**NUMBER:** 10-001-20

**GROUP:** 10 - Restraints

Airbag Warning Lamp (AWL) Illuminated B0028-13 and B0020-13

This bulletin involves inspecting and installing a jumper harness in the front seats if needed.

Fig. 1  
Terminal Locations for KL Vehicles.

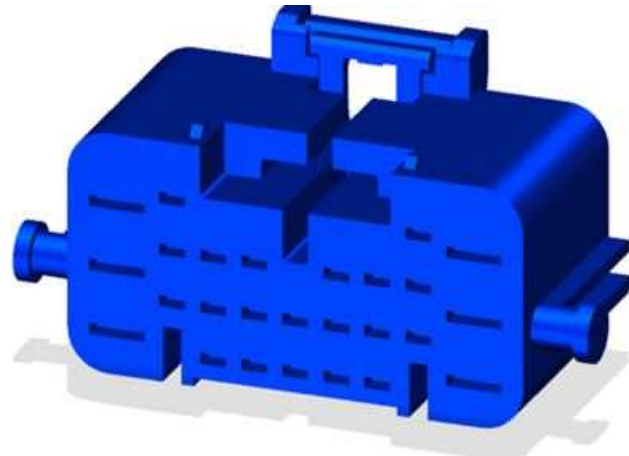
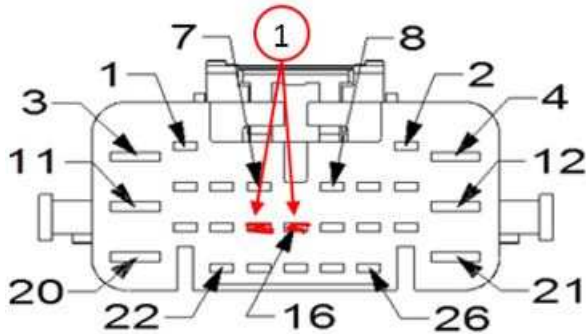
1 - \*\*The cavity numbers for both left and right seats are 15 and 16.\*\*

Fig. 2  
Terminal Locations for UF Vehicles.

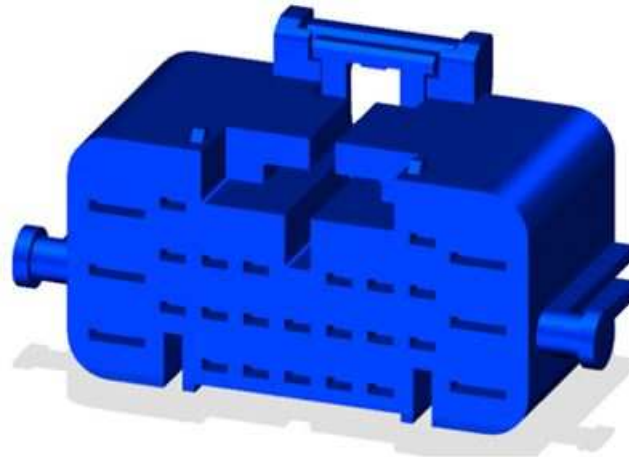
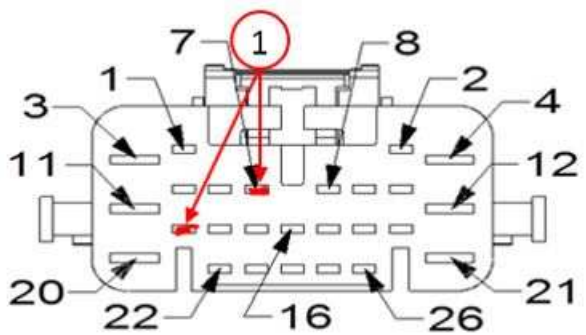
1 - \*\*The cavity numbers for both left and right seats are 7 and 13.\*\*

**Fig. 3**  
**Jumper Harness Routing**

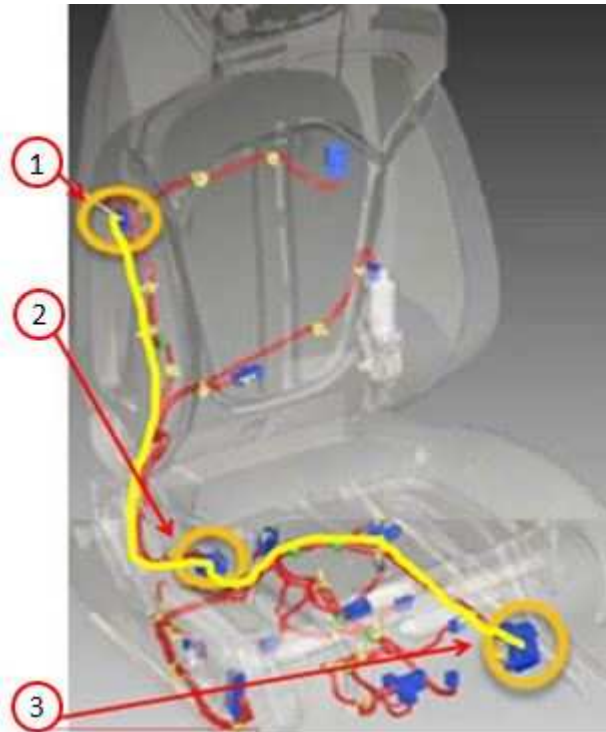
8. The jumper harness will be routed between the SAB and the Seat to Body in-line connector. The jumper harness will by-pass the seat cushion in-line connector. See (Fig. 3) for jumper harness routing.

Fig. 5  
Seat Bottom

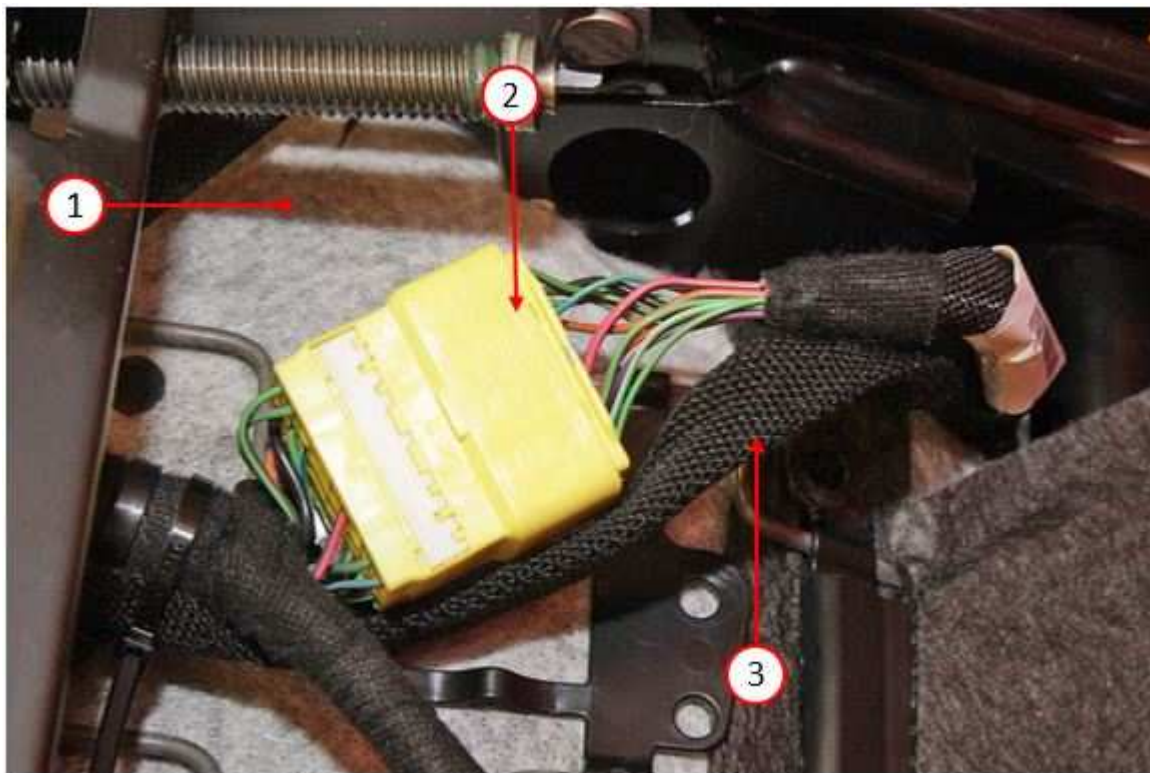
11. Route and secure the jumper harness along the existing seat back harness, see (Fig. 4) .  
By-pass the seat in-line and continue to route the jumper on the seat cushion harness, see (Fig. 5) .
